ERIN HILLS – UNIT 4D
SUBDIVISION OBSERVATION REPORT

July 25, 2012

HR GREEN JOB NO. 86120056

Erin Hills – Unit 4D Subdivision Observation Report

ERIN HILLS UNIT 4D
 BASIN #1

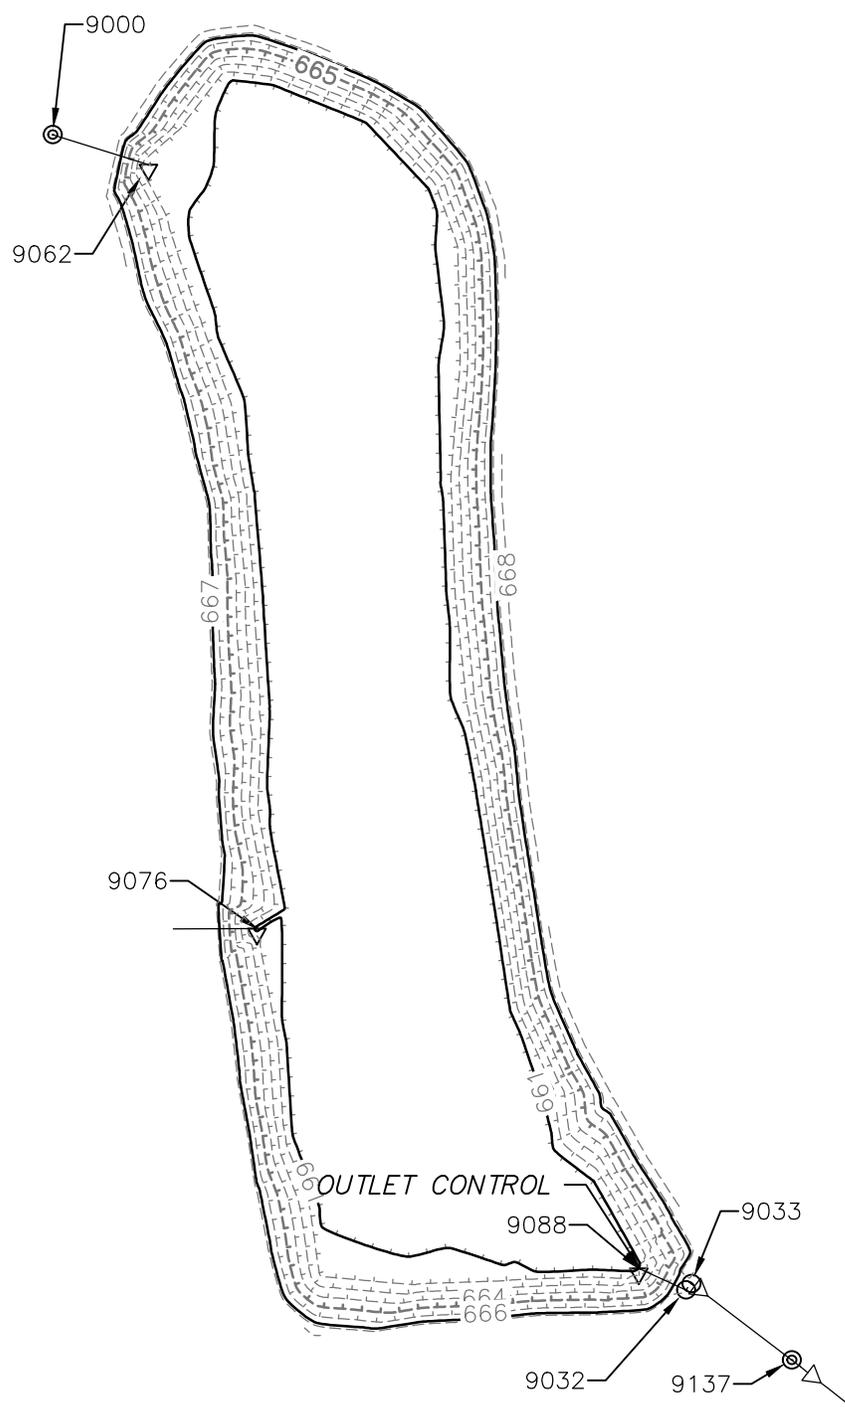
For Basin #1, the surveyed storage volume is calculated to be 12.12 Ac-ft. The design plans label this basin as providing 14.10 Ac-ft of storage. The corresponding difference between design storage and as-built storage volume provided is approximately 2.0 Ac-ft or a 14% shortage. The design plans call for Basin#1 to have a normal water level (NWL) of 660.80 and a 100-YR high water level (HWL) of 667.8 or 667.30 (listed both ways on the plans). The surveyed NWL was found to be based upon the flared end section (FES) #9088, invert (INV) elevation of 661.0±. The HWL was found to be the ground elevations of 666.70 at the overflow weir near CB #9032.

Basin #1 is short in volume due to the fact that the outfall pipe was constructed 0.2' high and the overflow weir was constructed 1.1' low. One possible corrective measure would be to raise the basin overflow weir and containment berm to obtain additional volume. A detailed analysis of the original design calculations and existing site conditions would be necessary before this measure could be recommended. HR Green can provide this service at an additional cost.

ERIN HILLS UNIT 4D
 BASIN #2

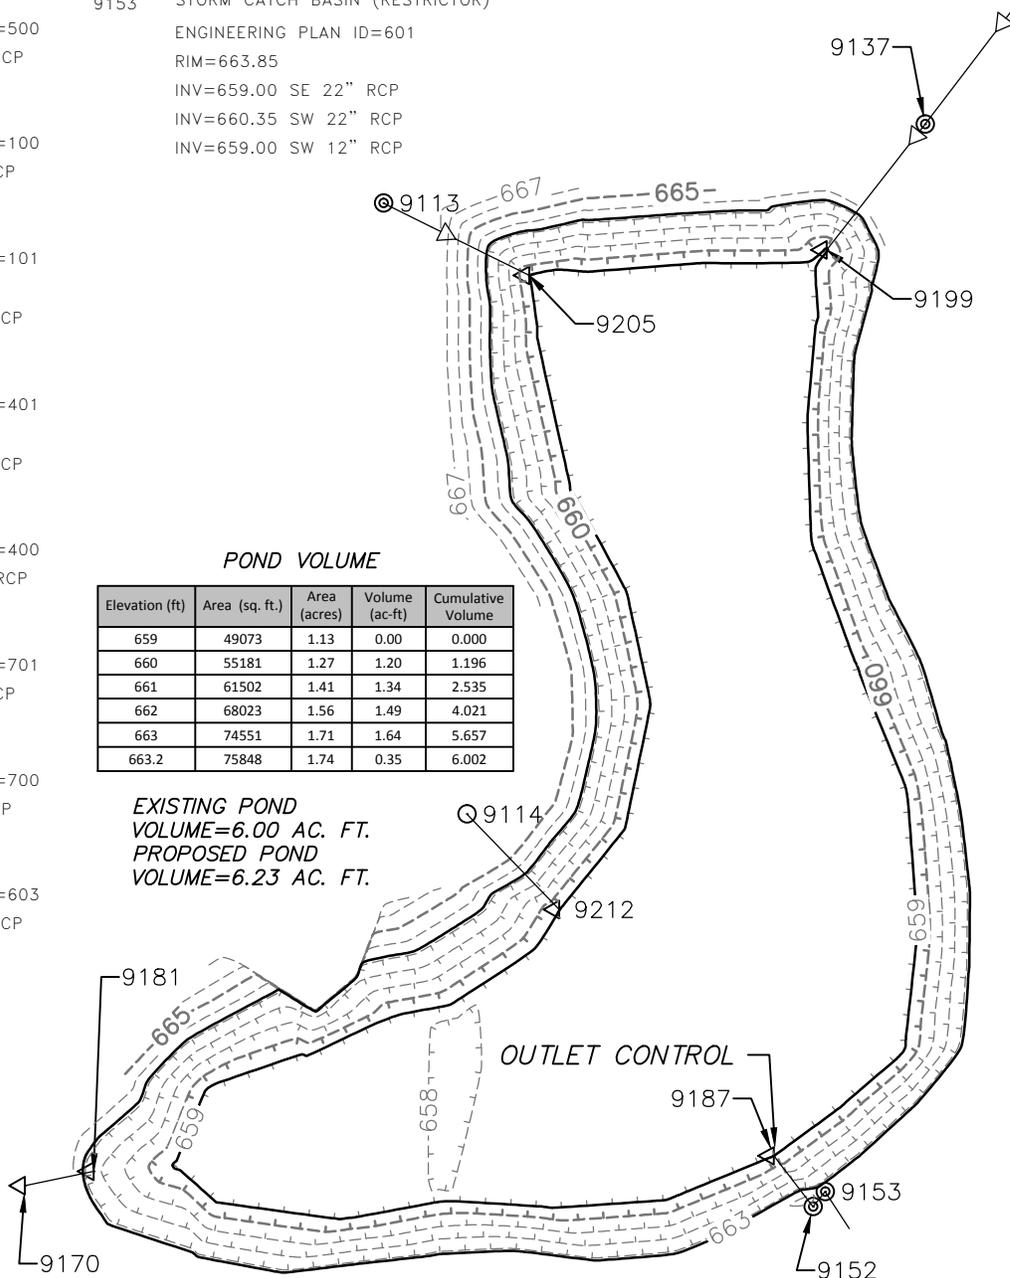
For Basin #2, the surveyed storage volume is calculated to be 6.00 Ac-ft. The design plans label this basin as providing 6.23 Ac-ft of storage. The corresponding difference between design storage and as-built storage volume provided is approximately 0.2 Ac-ft or a 4% shortage. The design plans call for Basin #2 to have a normal water level (NWL) of 659.00 and a 100-YR high water level (HWL) of 663.00. The surveyed NWL was found to be based upon the flared end section (FES) #9187, invert (INV) elevation of 659.00. The HWL was found to be the ground elevations of 663.20 at the overflow weir along the pond's eastern bank.

Basin #2 is also short in volume by 4% of the proposed design. The NWL and HWL elevations match the proposed design. If corrective measures are deemed necessary adjustments to the overflow weir or outfall pipe can be evaluated. Likewise, a detailed analysis of the original design calculations and existing site conditions would be necessary. HR Green can provide this service at an additional cost.
